TECHNICAL APPENDIX B:
ANALYSIS OF BSS-NORTHPOINT INTERFERENCE
ISSUES
DIRECTV, INC.
March 2, 1999

1 OVERVIEW: PROPOSED SPECTRUM POLICY FOR PROTECTING BSS OPERATIONS FROM NORTHPOINT'S TERRESTRIAL OPERATIONS

Figure 2.1-2 DIRECTV corrected graph of RSSi versus range (calculated using a Northpoint transmitter tower height of 200 m and an antenna tilt of 5 degrees).

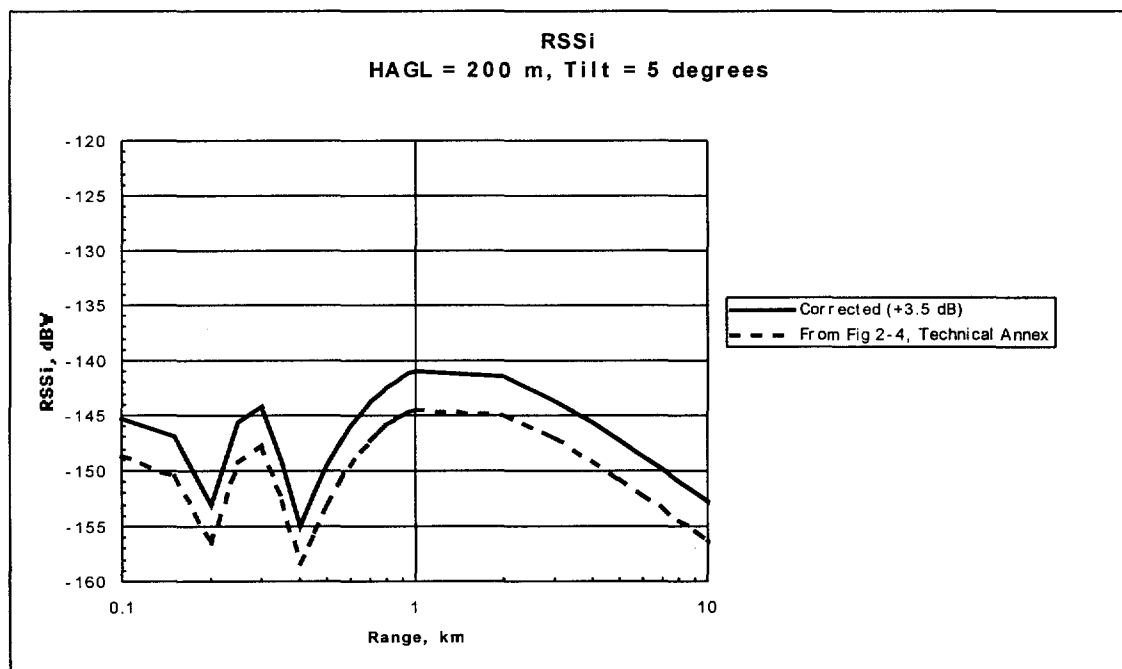
Reconstructing the data shown in Figure 2-1 of the Northpoint Technical Annex indicates that the values for the parameters noted above had not been set to zero in the Northpoint provided calculations. The impact of this error is to raise the RSSi curves in Figures 2-1, 2-2, 2-3, and 2-4 of the Northpoint Technical Annex by 3.5 dB.

DIRECTV then used the vertical gain pattern for the Northpoint antenna presented in the Engineering Exhibit to the Reply Comments of Northpoint prepared by Delawder Communications, Inc., to recreate the graph shown in Figure 2-4 of the Northpoint Technical Annex. As shown in Figure 2.1-2 below, the corrected curve is now 3.5 dB higher than the data presented in Figure 2-4 of the Northpoint Technical Annex.

Figure 2.2.4-1 Graph of Northpoint generated RSSi versus maximum permissible RSSi (calculated using corrected BSS link parameters).

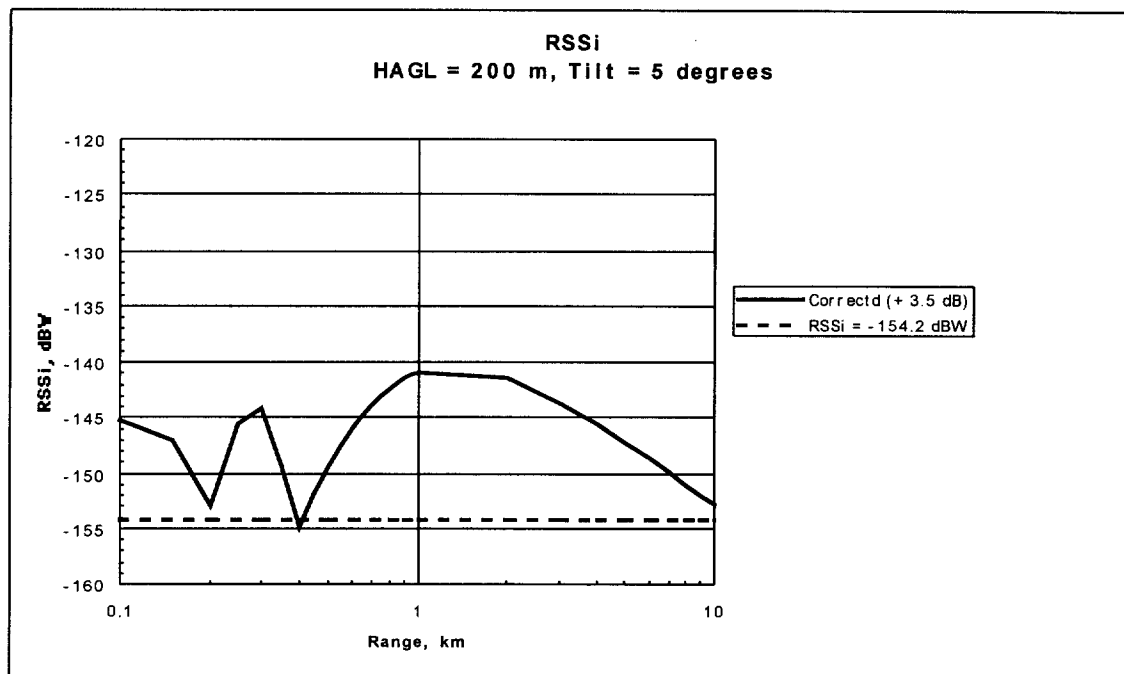
Figure 2.2.4-1 shows Figure 2.1-2 with a horizontal line added to represent $\text{RSSi} = -154.2 \text{ dBW}$ as required from Table 2.2.2-2. Regions where the RSSi is greater than or equal to -154.2 dBW have unacceptable levels of interference. *It is clear that virtually the entire Northpoint operating zone from the transmitter out to about a 12-km range will produce unacceptable interference into the US-GSO 1(a) link.*

Figure 2.2.4-2 Estimate of required separation distance with BSS earth station (BSS antenna horizon gain is 0 dBi and Northpoint tower height is 150 m).

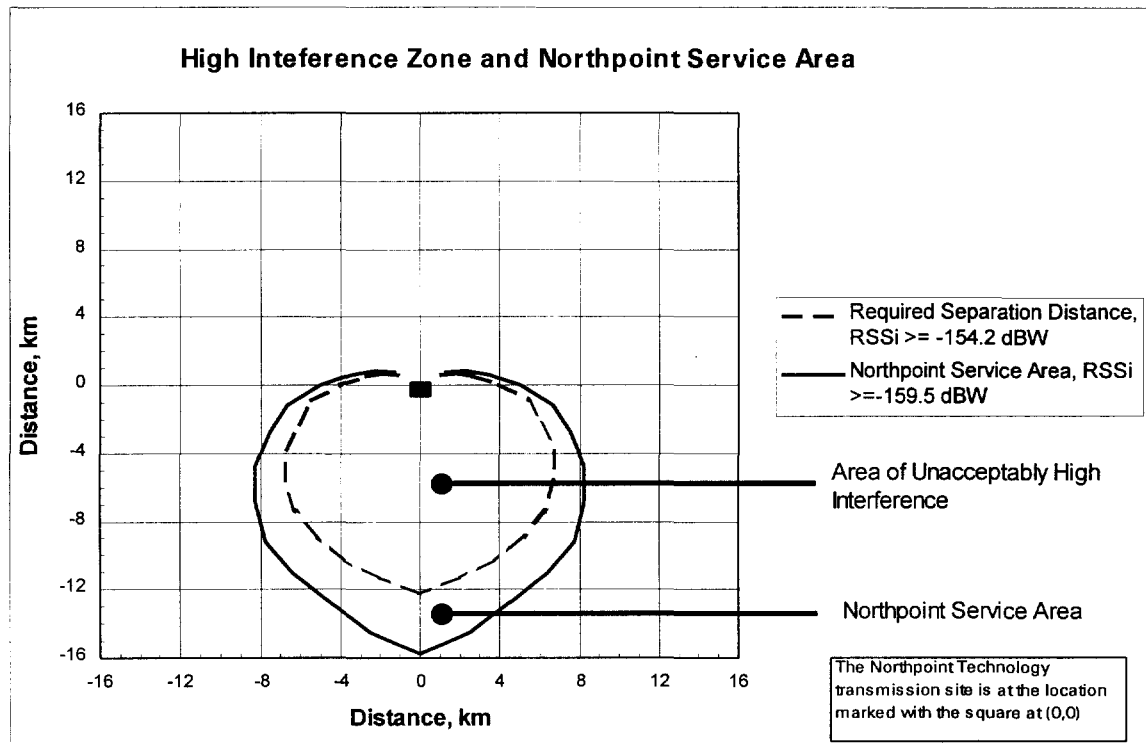
Figure 2.2.4-2 shows the minimum separation distance calculated using a maximum permissible RSSi of -154.2 dBW (corresponding to $C/I = 28.6$ dB) and with a RSSi of -159.5 dBW defining the Northpoint service area. The dashed line in Figure 2.2.4-2 represents the required separation distance between the Northpoint transmitter and the BSS receive antenna. Any BSS receivers closer to the Northpoint transmitter than this separation distance will receive *unacceptably high interference*. This is a very large area (more than 50% of the service area), and it is *absurd* to expect to be able to perform some form of mitigation (such as shielding) on all BSS receivers in this large area. In addition, receivers outside this area will receive high interference levels due to multipath effects, which are very unpredictable. This calculation uses a Northpoint tower height of 150 m, a tilt of zero degrees, and a horizon gain for the BSS antenna of 0 dBi. These calculations include the $(1/\text{range}^2)$ falloff of transmit signal power, as well as estimates of the Northpoint transmit antenna gain pattern. The antenna gain pattern is based on information from the Northpoint Technical Annex and its associated Engineering Exhibit prepared by Delawder Communications. Terrain features are not included in this general analysis. To calculate the Northpoint service area DIRECTV used the link budget developed in the Northpoint Technical Annex and shown in Figure 2.1-1 above.

From these calculations it is possible to make general comments about the size of the high interference zone. The high interference zone is defined as the area enclosed by the dashed line, and it is a significant part of the overall Northpoint service area (which is defined by the solid line). The operating zone for Northpoint would feature RSSi values between -154.2 and -159.5 dBW, a difference of only 5.3 dB. As can be seen from Figure 2.2.4-2, the high interference zone extends well beyond those ranges where tilting the Northpoint transmitting antenna reduces the RSSi. Rather, it is in the regime where the fall-off of RSSi depends on distance from the transmitting site (the well-known $1/\text{range}^2$ dependence for electromagnetic-wave propagation). This is highlighted in Figures 2.2.4-2 and 2.2.4-3 which show the Northpoint service areas (that is, areas where the Northpoint RSSi is -159.5 dB or higher) and the required separation distance to protect BSS (line where the Northpoint RSSi is -154.2 dBW). Figure 2.2.4-2 is similar to Figure 2.2.4-3 except that a Northpoint antenna height of 200 m and a beam tilt of 5 degrees are used in Figure 2.2.4-3 (as described in Northpoint's Technical Annex).

Note that under clear sky conditions and no fade margin, the Northpoint service area (which will be referred to as the "clear sky service area") extends out to about 24 km from the transmitting site. When the service area is calculated by including an additional -3.5 dB to account for rain fade and other effects (as described in the Northpoint Technical Annex) the maximum service distance shrinks to about 16 km. Under these

conditions, the high interference zone is *more than 50% of the actual Northpoint service area*.

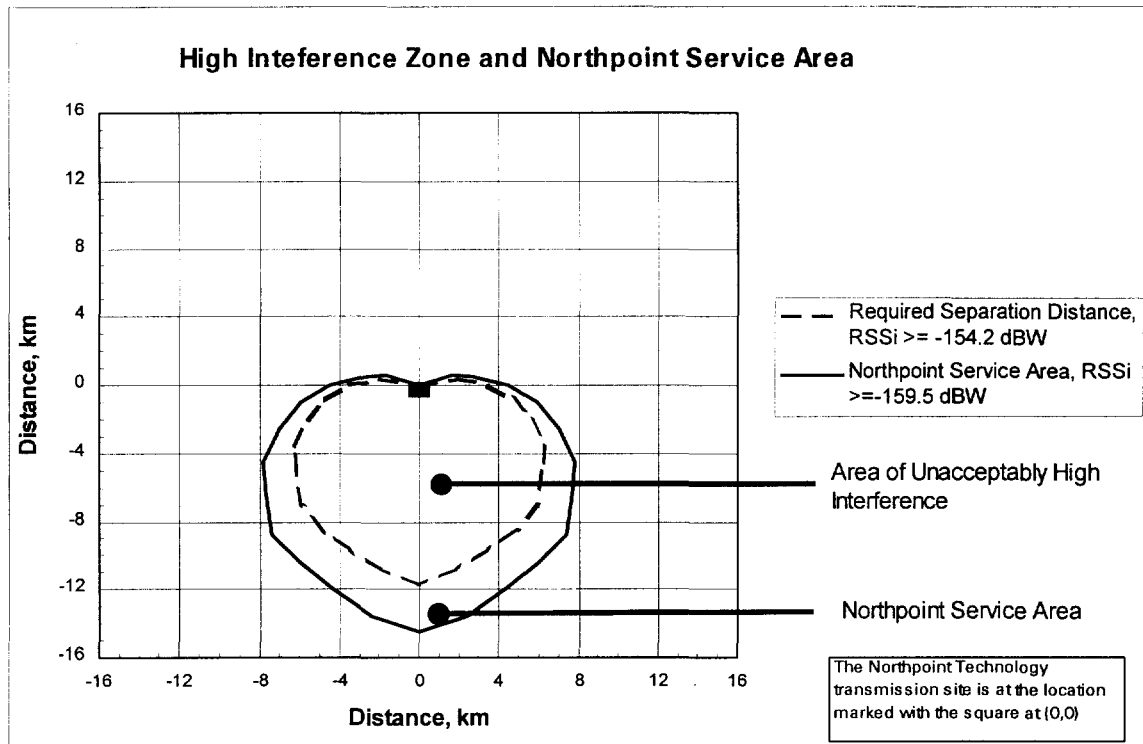
Another issue regarding separation distances needed to protect BSS systems can be observed in these figures. It is apparent that significant overlap between Northpoint operating zones will be required. If a BSS receiving system is located near the boundary of two or more Northpoint service areas, the BSS system will encounter interference from *each* Northpoint system. This means that the aggregate interference for these BSS receivers will consist of contributions from multiple Northpoint signals originating from different directions, and the aggregate interference may be significantly higher than would be expected from only one Northpoint system alone. Furthermore, as stated in Northpoint's testimony before the House Commerce Subcommittee on Telecommunications, Trade and Consumer Protection on February 24, 1999, "[i]n the Northpoint system, most customers will have at least 3 directions to point their dish to pick up our service."⁶ Hence, contributions from multiple interference sources will result in an

appreciably higher aggregate interference on BSS receiving systems -- by Northpoint's own admission, perhaps *three times* (4.77 dB) as much.

Figure 2.2.4-4 Estimate of required separation distance with BSS earth station (BSS antenna horizon gain is 0 dBi, Northpoint tower height is 50 m, and Northpoint antenna tilt is 5 degrees).

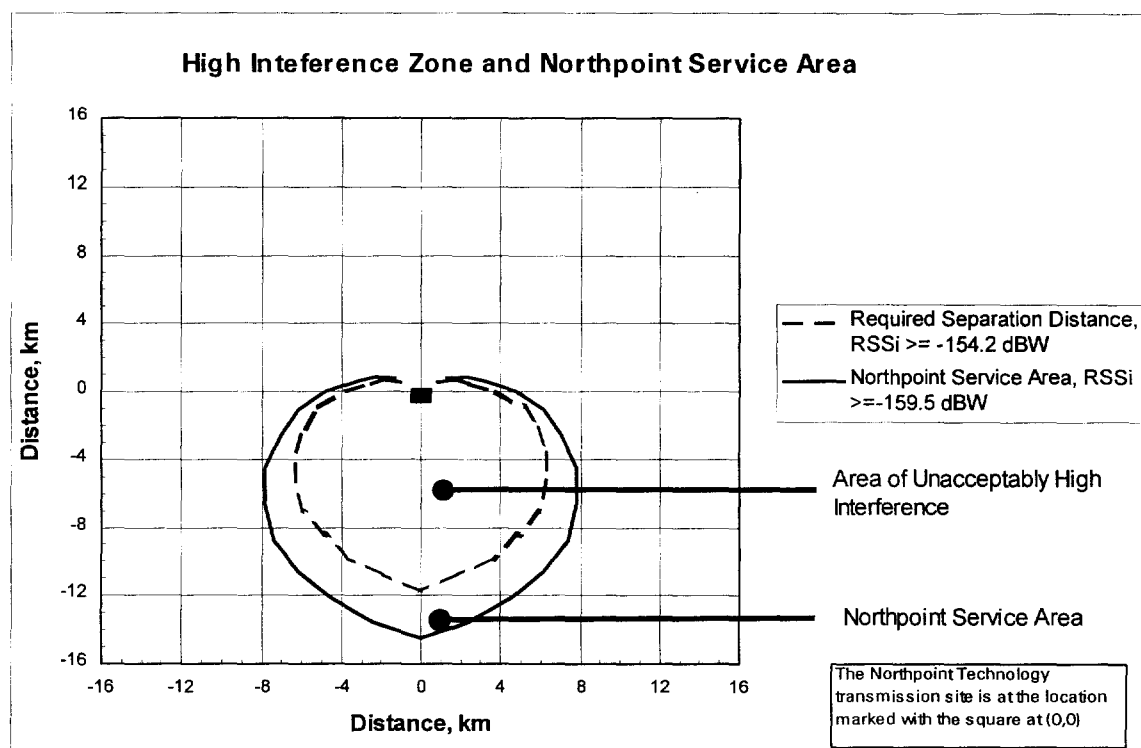
Similar calculations can be performed for Northpoint transmitter siting scenarios which would be much more reasonable than those using very tall towers. Figure 2.2.4-4 displays the required separation distance and Northpoint service area calculated using a transmitter tower height of 50 m and a Northpoint antenna tilt of 5 degrees. The high interference zone and the Northpoint service area are very similar to those shown in Figure 2.2.4-3.
